HIGHLAND SPRINGS 2ND ADDITION

S/D 99-29 -- Final Plat of HIGHLAND SPRINGS SECOND ADDITION

S/D 99-29 -- Final Plat of HIGHLAND SPRINGS SECOND ADDITION

CASE NUMBER: S/D 99-29 - HIGHLAND SPRINGS 2ND ADDITION

HIGHLAND SPRINGS 2ND ADDITION

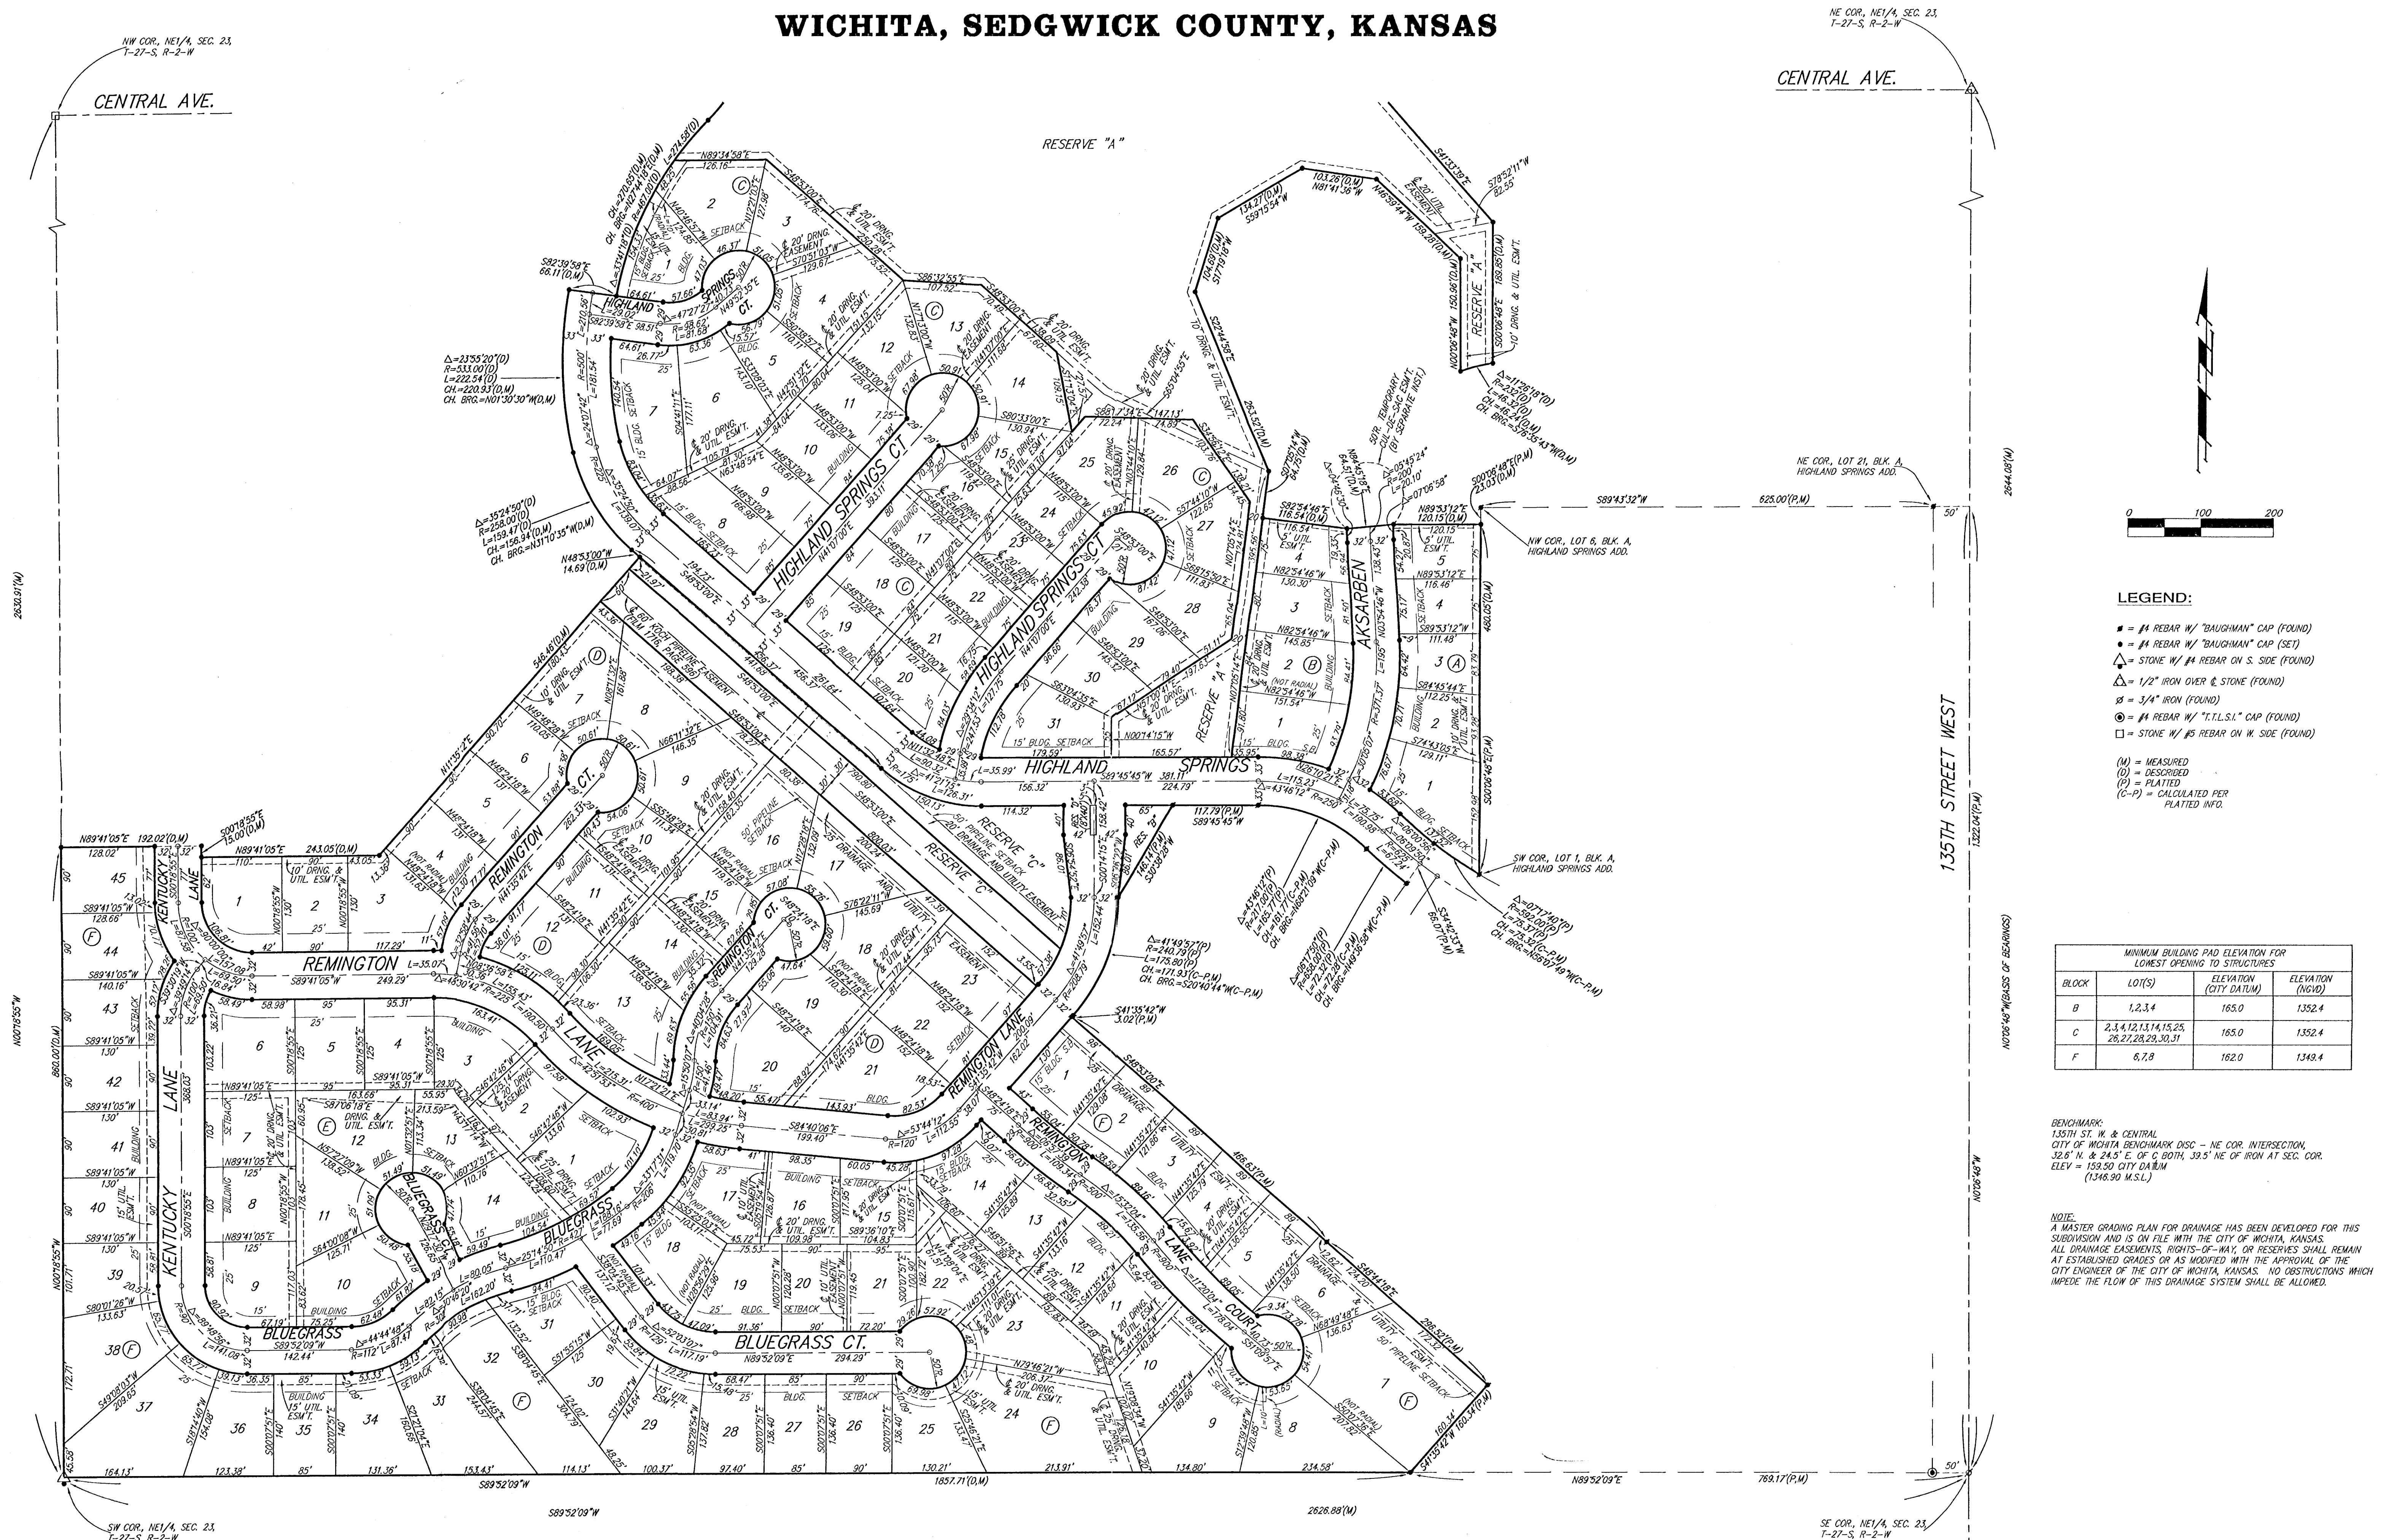
- A. The site is located within the Northwest Wichita sewer growth limits. The applicant shall guarantee the extension of sanitary sewer and City water to serve the lots being platted.

- C. City Engineering needs to comment on the status of the applicant's drainage plan. The drainage plan is approved. A guarantee is required.
- D. The applicant shall guarantee the paving of the proposed interior streets. Highland Springs shall be paved to a collector street status, and sidewalks shall be guaranteed along both sides of the street. Sidewalks shall be guaranteed on one side of the non-cul-de-sac streets - Remington Lane, Kentucky Lane and Rolling Hills. A temporary turnaround for Rolling Hills shall be established by separate instrument.

- E. The applicant shall submit a copy of the instrument which establishes the pipeline easements on the property, which verifies that the easements shown are sufficient and that utilities may be located adjacent to and within the easements.

- F. The applicant's agent shall determine any setback requirements for the pipelines by researching the text of the pipeline agreements. If a setback from the pipeline easements is provided for in the pipeline easement agreements, it shall be indicated on the face of the plat.

- I. City Fire needs to comment on the acceptability of the street names. Several street names are not in compliance with the 12-character street name limitation. City Fire has requested that Rolling Hills be revised to Aksarben Street, Binter Circle be revised to Highland Springs Court, Remington Lane Court be revised to Remington Court. The east-west portion of Kentucky also needs to be revised to Bluegrass Street and Kentucky Lane Ct be revised to Bluegrass Court. Traffic Engineering has requested that Highland Springs be revised.

- N. The platlor's text shall include language that a drainage plan has been developed for the plat and that all drainage easements, rights-of-way, or reserves shall remain at established grades or as modified with the approval of the applicable City or County Engineer, and unobstructed to allow for the conveyance of stormwater.

- O. The minimum building opening elevations shall be designated in National Geodatic Vertical Datum (NGVD) and City Datum.
- P. Complete access control shall be dedicated along Central and referenced in the platlor's text.

- Q. To obtain a second point of access for fire vehicles, an emergency access easement shall be platted along the north line of the plat. No obstructions will be allowed in the easement except for any gates as is approved by the City Fire Department. The applicant shall also be responsible for the installation of an acceptable driving surface or other improvements as is determined by the City Fire Department.
